AEROSTAR
SERVICE BULLETIN #121

28 July 1986

SUBJECT Ball Pyrometer Infrared Sensitivity

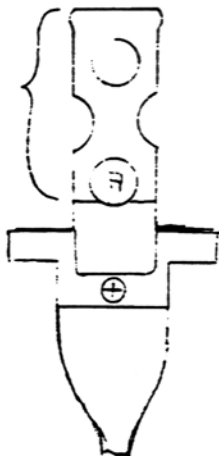
PROBLEM The Digital Pyrometer which is part of the Ball 655R instrument package has been determined to be susceptible to abnormally high readings due to radiant infrared heating during burns.

Step 3: Fully coat the sensor as shown in the following diagram. Ensure that the thermistor which is contained inside the protective shield is fully coated but is not left with an excessively thick layer of paint.

Coat Nominally
1 inch with White
Titanium Dioxide

CORRECTIVE ACTION The sensitivity to infrared heating can be substantially reduced by coating the sensor with a titanium dioxide white paint. Titanium dioxide based white provides the greatest re-radiation or reflection of infrared heat available. Testing has indicated this does not adversely affect the response time of the sensor.

Step 1: Obtain a titanium dioxide based paint (Rust-oleum Satin White #7791 is recommended and widely available.) Spray or liquid is acceptable.

Step 2: Locate the sensor in the upper portion of the balloon. Ensure there is no dirt or grease on the sensor.
